PETITION FOR VARIANCE APPLICATION

Name of Owner MARC LIFSATH	Project Description UNIVERSITY BASED HOUSING PROJECT WITH RETAIL AND ENCLOSED PARKING	Agent, architect, or engineering firm ANTUNOVICH ASSOCIATES
Company (if applies) CORE CAMPUS	Tenant name (if any)	No. & Street 224 WEST HURON STREET
No. & Street 2234 W. NORTH AVENUE	Building Address 441 N. FRANCES STREET	City, State, Zip Code CHICAGO, IL. 60654
City, State, Zip Code CHICAGO, IL. 60647	Phone 312-266-1126	Name of Contact Person JEFF ZELSKO
Phone 773-227-2850	Building Address MADISON, WISCONSIN	e-mail JZELSKO@ANTUNOVICH.COM
e-mail MARC@CORECAMP.US

Rule Being Petitioned: IBC 705.8 Openings in exterior walls

The Hub at Madison - Combined Submittal Drawings

View Looking Southwest on State Street **34D**
 July 17, 2013

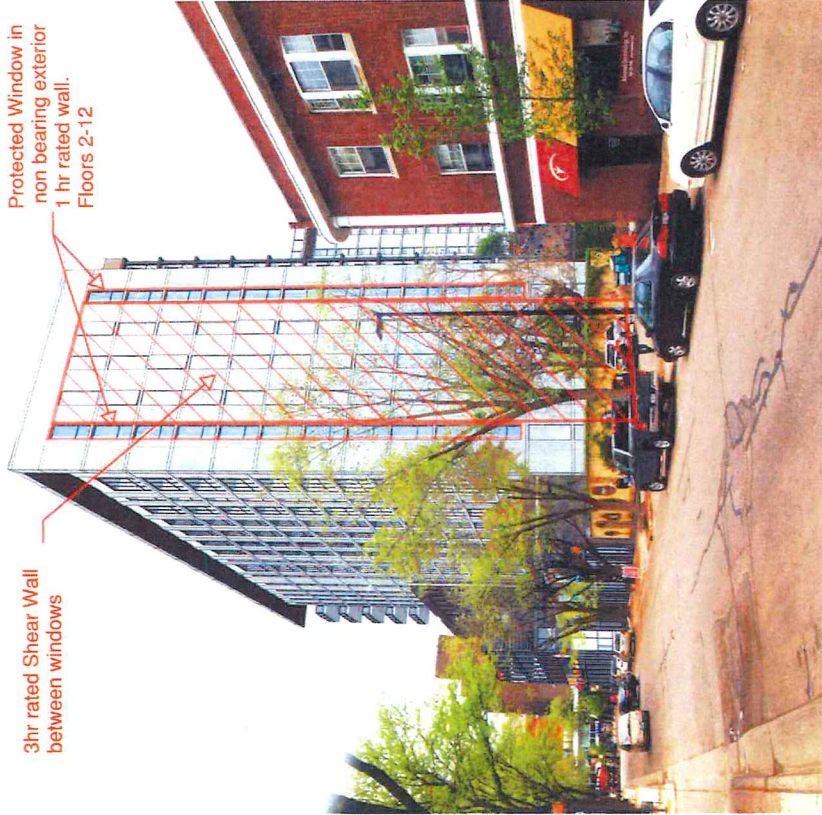
THE WINDOWS NOTED IN ITEM #2 ABOVE WILL EACH BE PROTECTED BY SPRINKLER HEADS ON BOTH SIDES OF THE GLASS, PROVIDING AN EQUIVALENT SEPARATION RATING TO THE REQUIRED 1 HOUR WALL. (SEE THE ENCLOSED PLAN, ELEVATIONS AND DETAILS SHOWING THE LOCATIONS OF THE WINDOWS AND THE SPRINKLER DETAIL TO BE LOCATED AT EACH OF THESE WINDOWS.

Protected Openings on
Property Line
See Sheet 34D for Elevation.

3hr rated Shear Wall between windows

Protected Window in non bearing exterior 1 hr rated wall. Floors 2-12

- The exterior exposure protection shall be automatic and shall have detection that is acceptable to the City of Madison Fire Department.
- These windows shall not be operable.
- The design shall comply with NFPA 13 or the listing of the TYCO Model WS window sprinkler.
- In the event a structure is built on any of the adjacent properties, that would make the exposure protection system inoperable or no longer maintainable, the affected openings shall be closed up with no indication on the interior that a window existed.
